MODEL 61/266

STARTER DEVICE

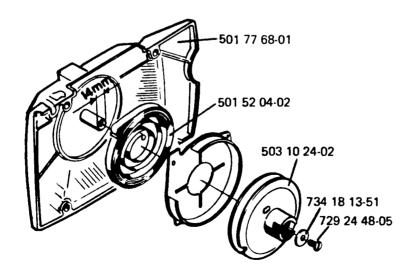
In order to obtain a better bearing surface for the pulley, a new starter assembly is introduced. The center post diameter is increased from 10 to 14 mm, which also means that a new pulley and recoil spring must be used.

Pulley 503 10 24-02 has a pulley sleeve, which is wider than the previous version and has also two grooves for easier identification.

The new versions of pulley, recoil spring, washer and screw cannot be used in the starter of the old type.

Starter compl. 501 77 67-01 can of course be used on old saws.
